Product Change Notification / ASER-28RAPG851

CCB 5128 Final Notice: Qualification of a new lead frame design and G700 as a new mold compound material for selected MIC277xxx device family available in 5L SOT-23 package assembled at STAR assembly site.

PCN #: ASER-28RAPG851

Lead Frame Design Comparison

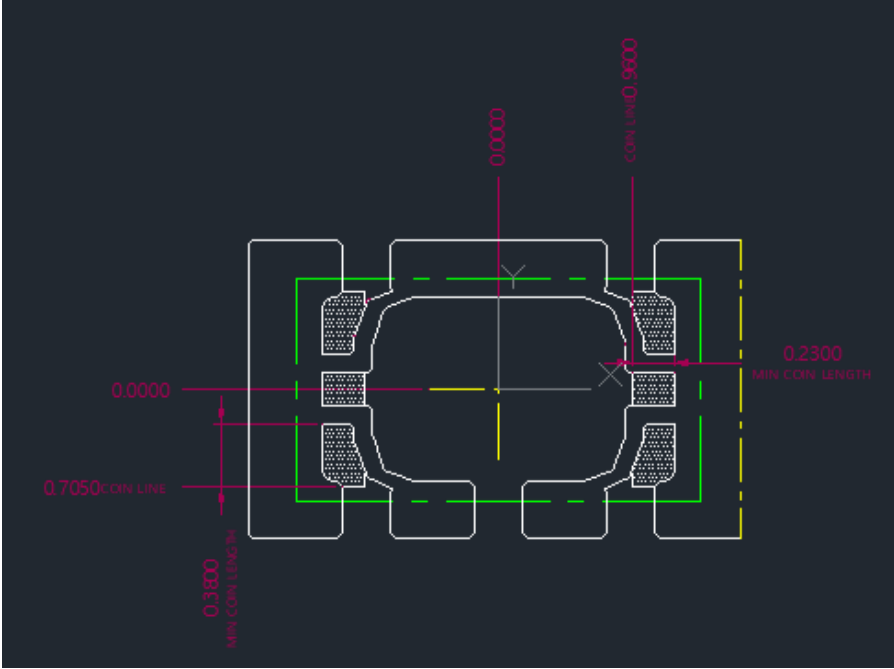
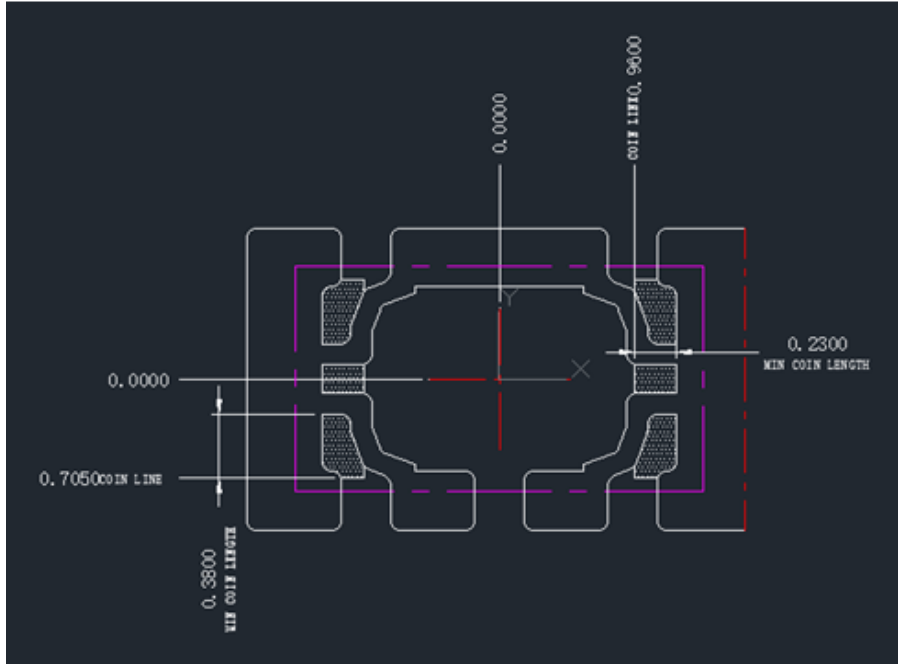
Description of Change:Qualification of a new lead frame design and G700 as a new mold compound material for selected MIC277xxx device family available in 5L SOT-23 package assembled at STAR assembly site.

Pre Change	Post Change
Assembly Site	Stars Microelectronics (Thailand) Public Company Limited (STAR)	Stars Microelectronics (Thailand) Public Company Limited (STAR)
Wire Material	Au	Au
Die Attach Material	84-1LMISR4	84-1LMISR4
Molding Compound Material	G600	G700
Lead-Frame Material	C194	C194
DAP Surface Prep	NiPdAu with Roughened	NiPdAuAg with Roughened
	See Pre and Post Change Summary for comparison.
